STATE HIGHWAY 105 / JACKSON CREEK PARKWAY - PHASE 2

CONSTRUCTION PLANS

Comments provided by DPW Development Services

Comments provided by DPW Capital Projects

REDI-ROCK RETAINING WALL JACKSON CREEK PARKWAY & STATE HIGHWAY 105

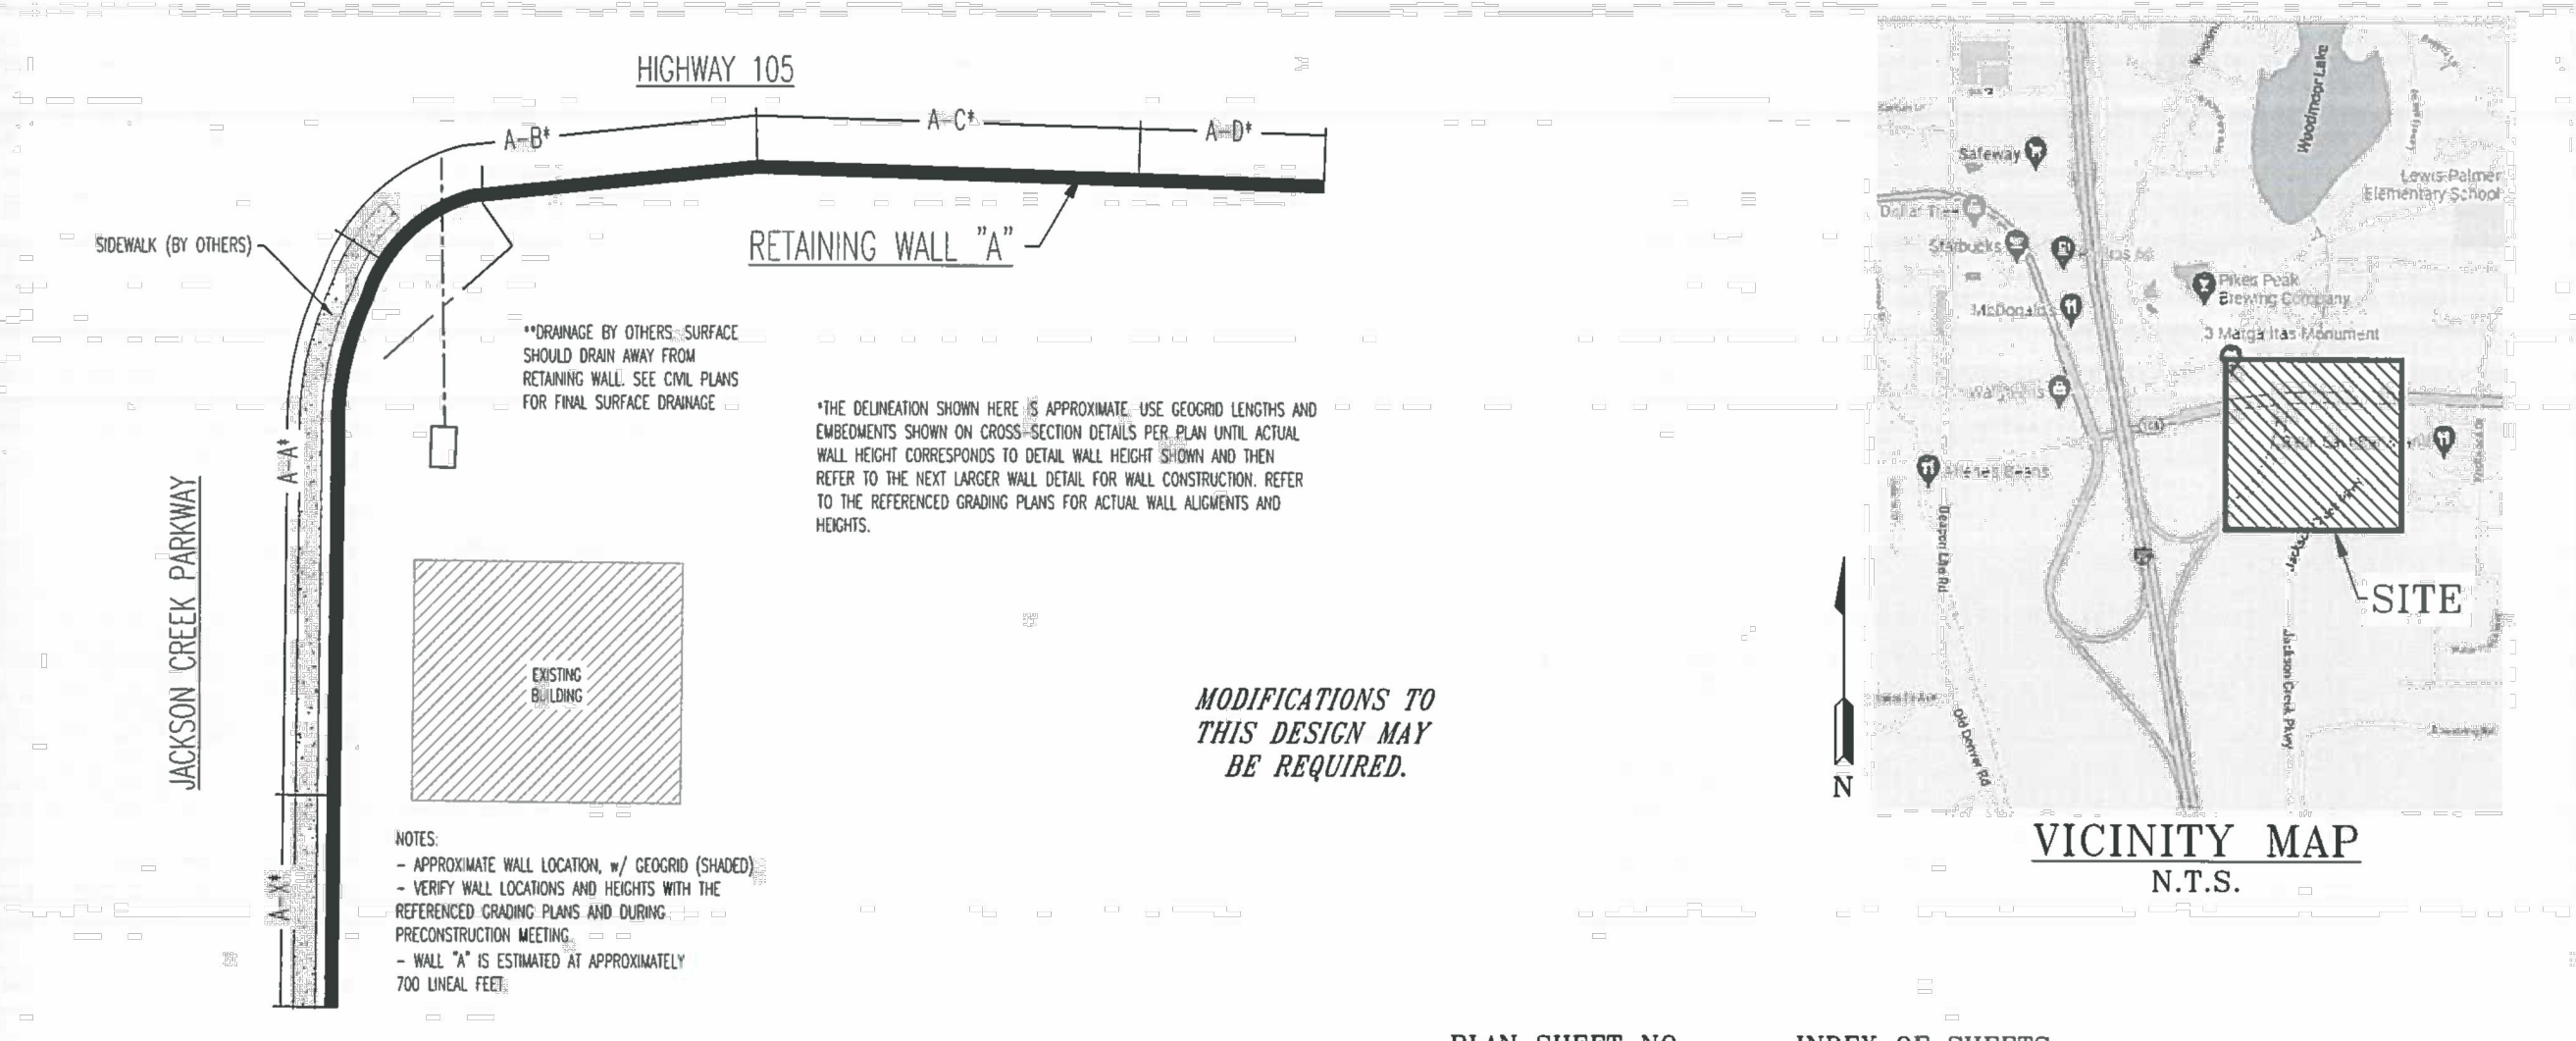
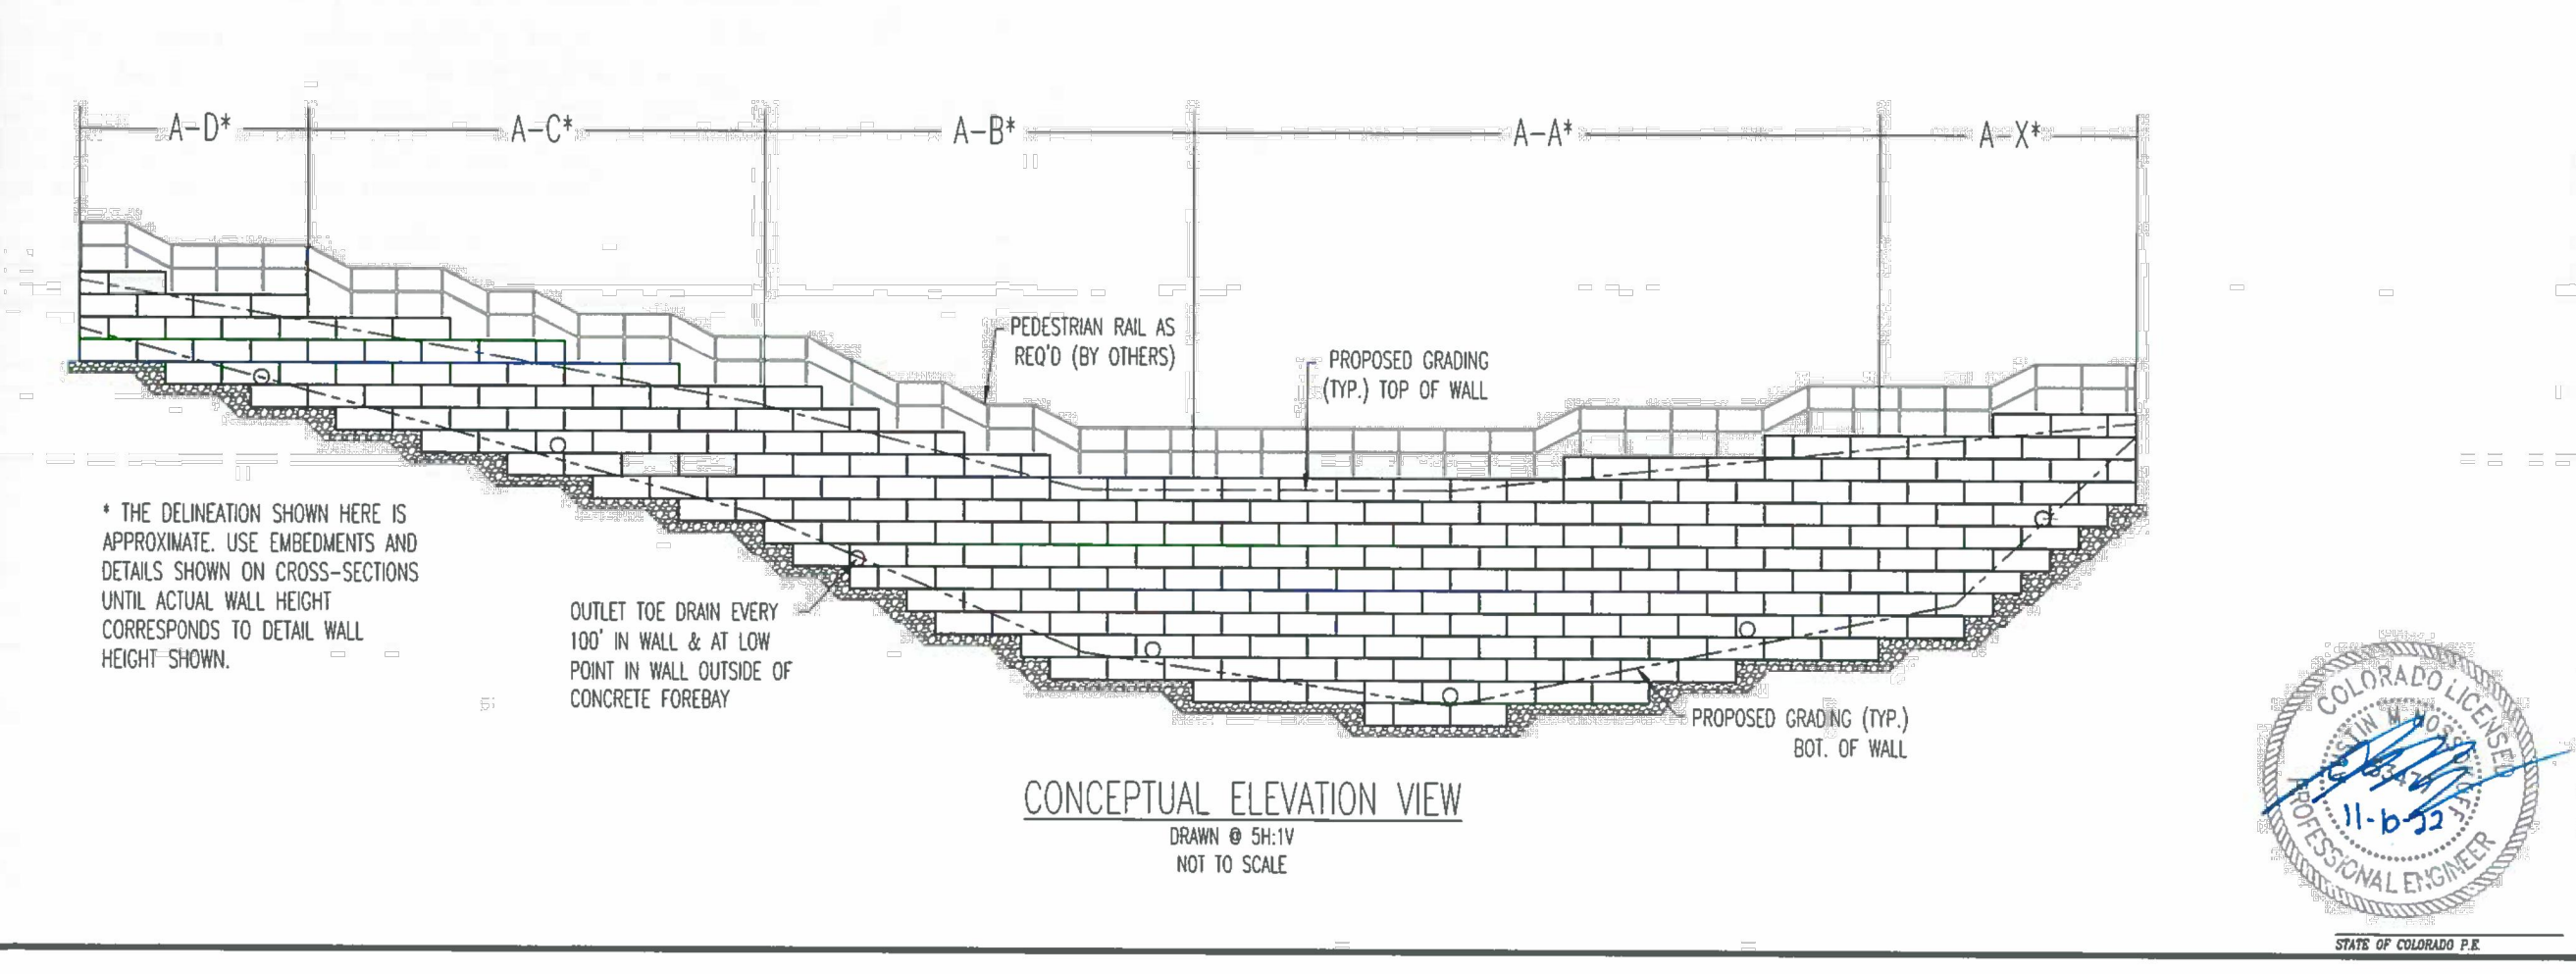
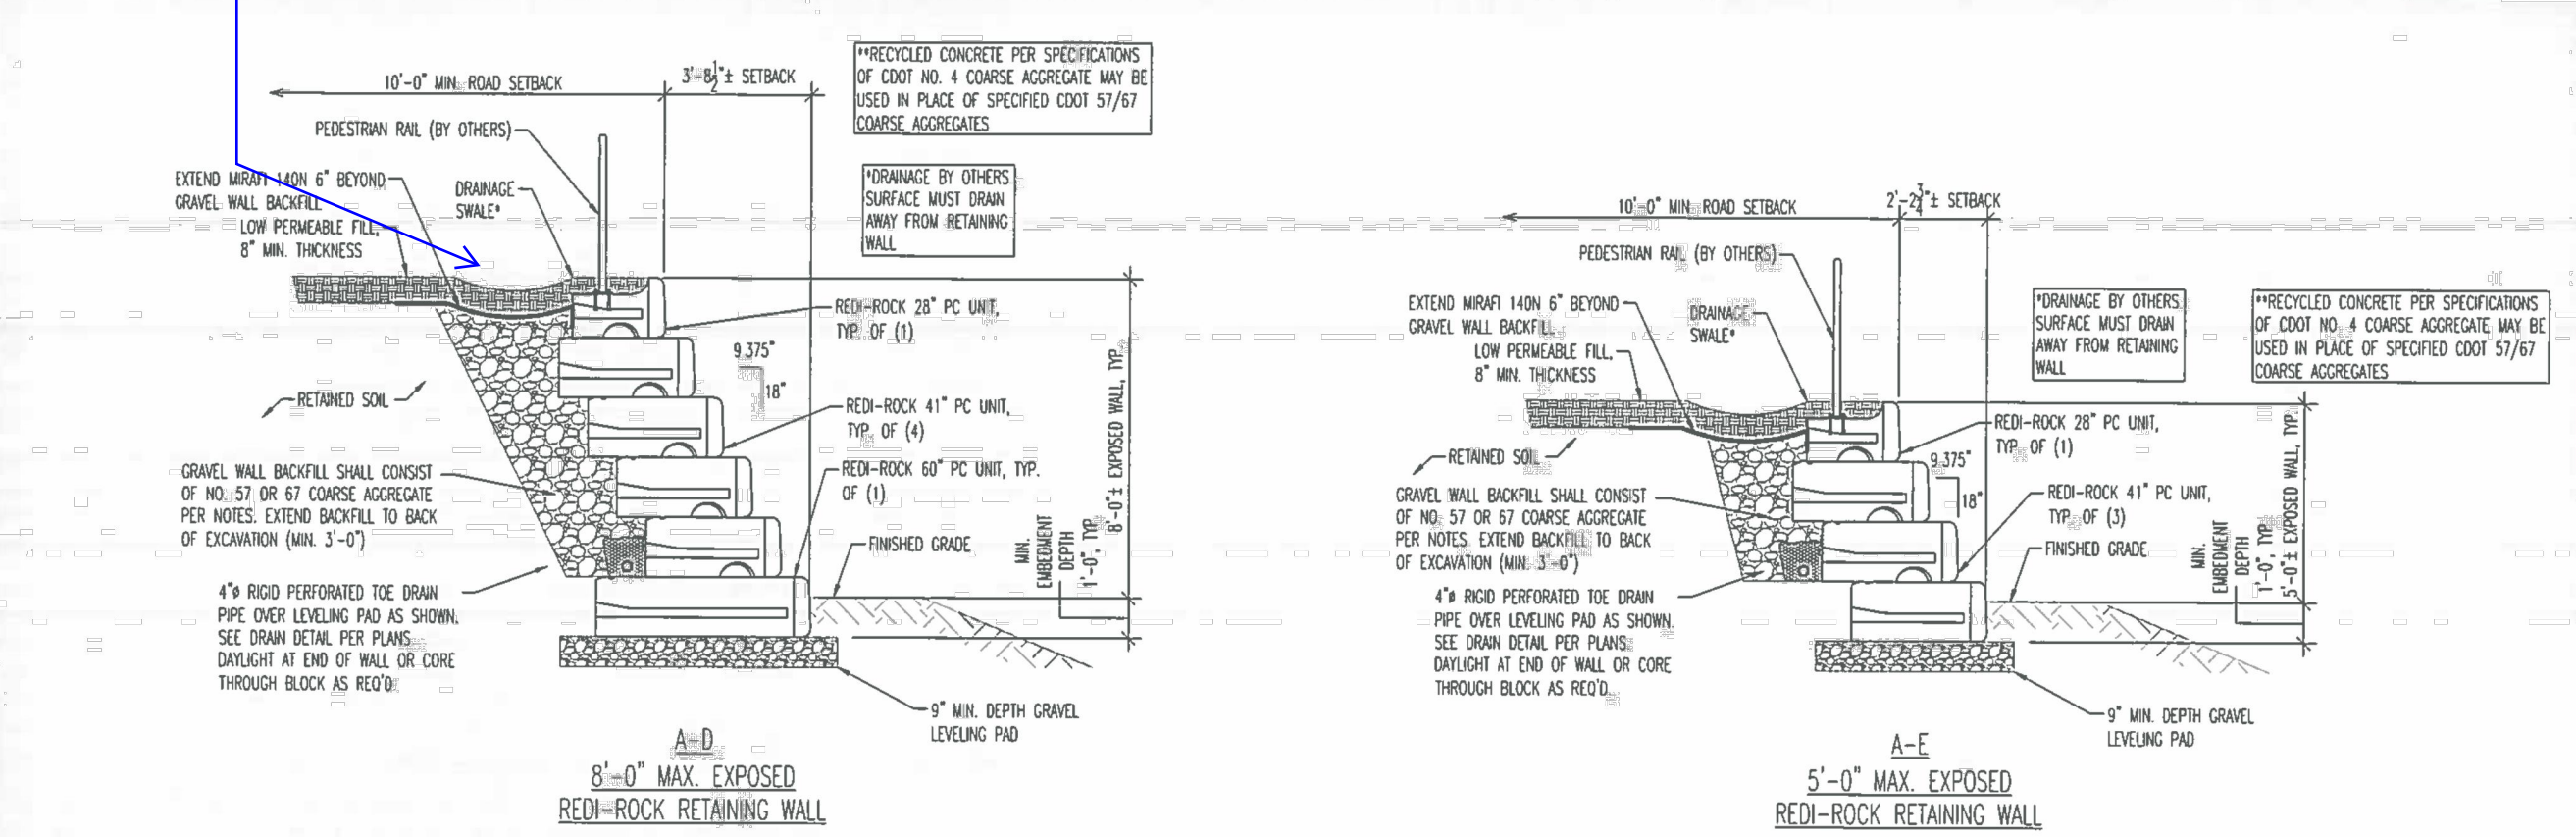
Include calculation in drainage report to show that swales is sized to adequately handle flow.
